City of Ketchum
Planning & Building

STAFF REPORT
KETCHUM PLANNING AND ZONING COMMISSION
MAY 28, 2024 MEETING

PROJECT: 490 Wood River Dr Residence

REQUEST: Floodplain Development Permit for a new 8,077 square foot residence and modification of wetland areas.

2 1/4" = 1'-0" EXTERIOR ELEVATION - WEST

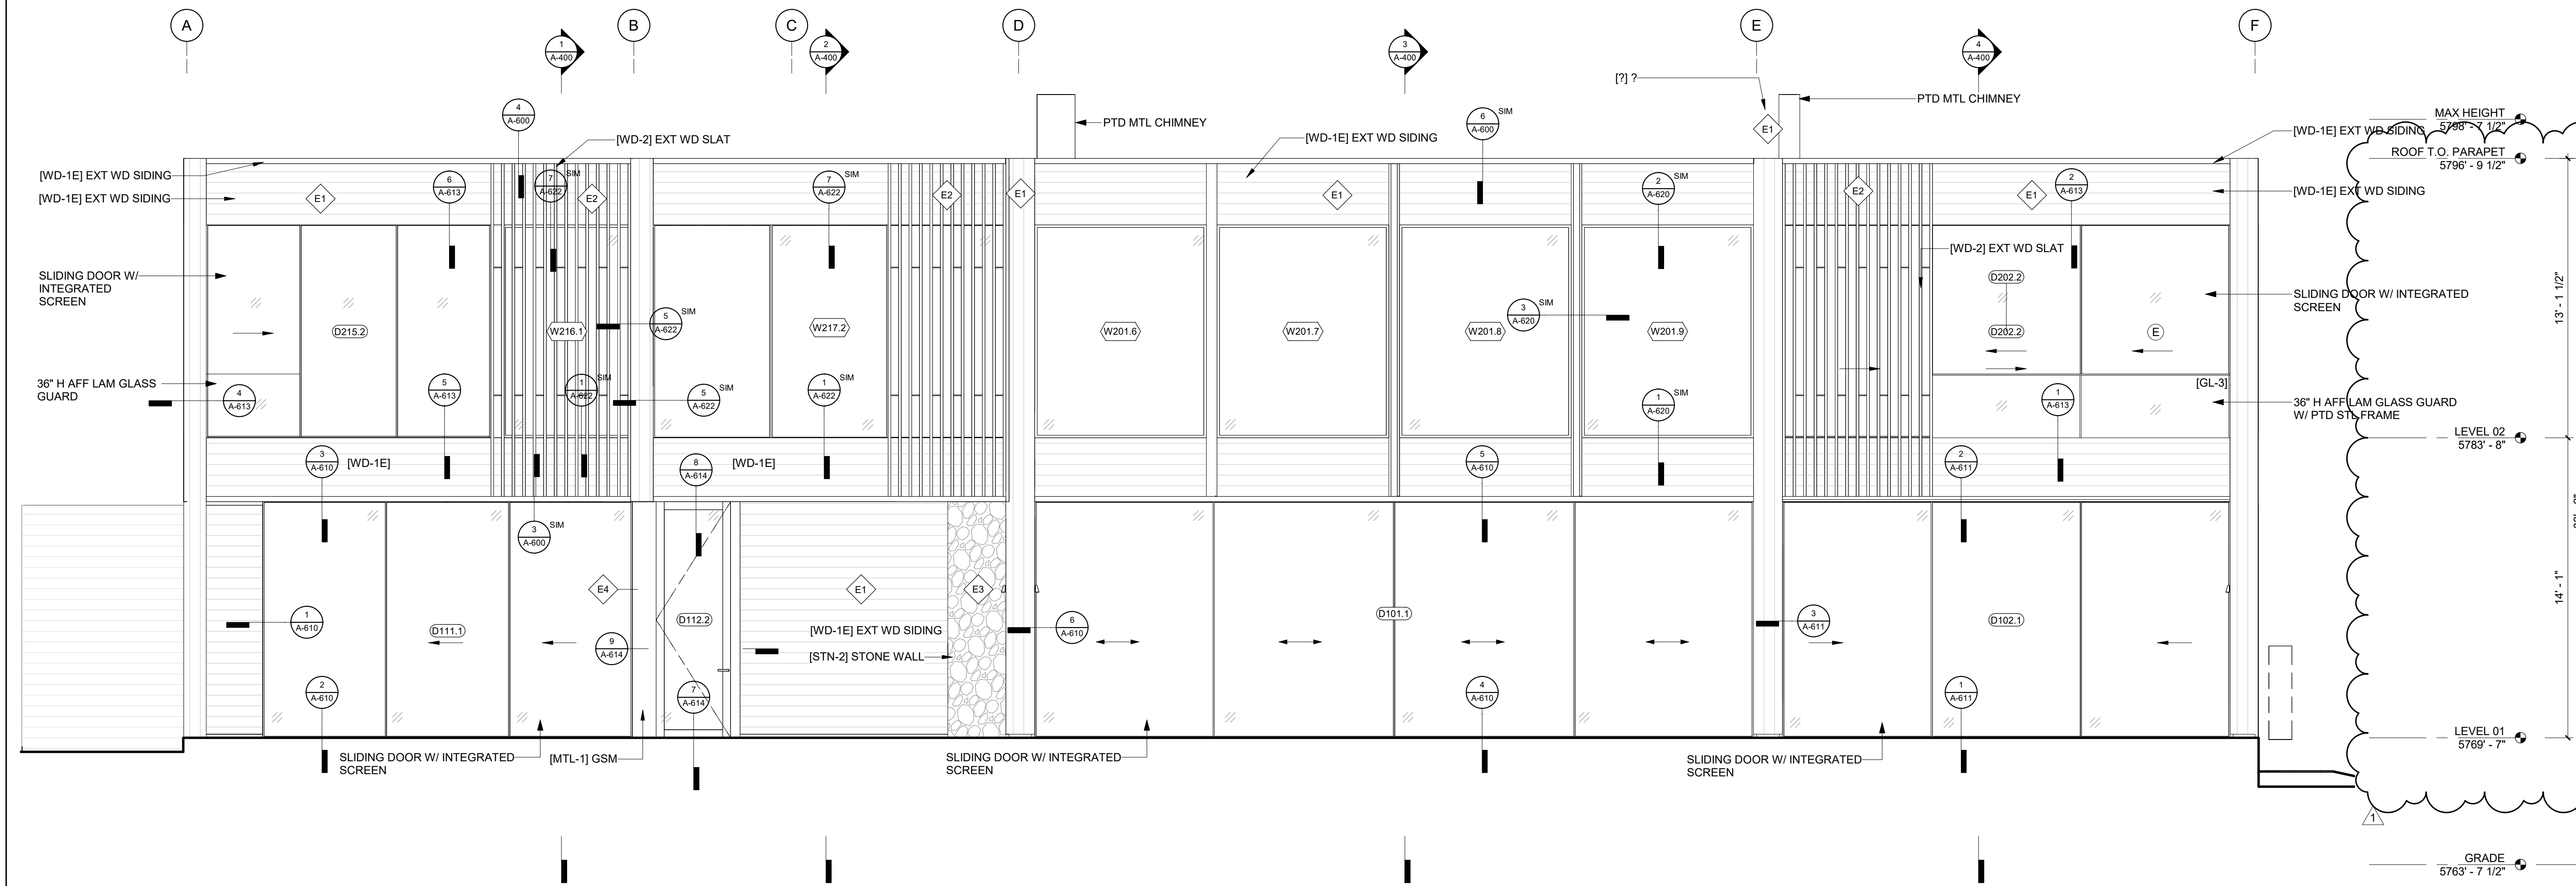
<i>Staff Comments</i>	<i>The top of the lowest floor (finished floor) is elevated 24" above the Base Flood Elevation of 5766.95 as shown on Sheets A-400 & A-401. As the proposed elevation is located within the AE zone the top of the lowest floor is required to be 24" above the BFE.</i>
<input checked="" type="checkbox"/>	<input type="checkbox"/>	<input type="checkbox"/>	17.88.050(E)10	<p>The backfill used around the foundation in the SFHA floodplain shall provide a reasonable transition to existing grade but shall not be used to fill the parcel to any greater extent.</p> <p>a. Compensatory storage shall be required for any fill placed within the floodplain.</p> <p>b. A CLOMR-F shall be obtained prior to placement of any additional fill in the floodplain.</p>
			<i>Staff Comments</i>	<i>Backfill used around the foundation which provides a reasonable transition to existing grade is not considered as part of the compensatory storage requirement. The proposed cut on the site is 638.1 cubic yards while the proposed fill not associated with the residence is 265.4 cubic yards, resulting in a net cut-fill balance of 372.7 cubic yards. The proposed cut occurs around modified drainage channels and wetlands which are hydraulically connected to the Big Wood River.</i>
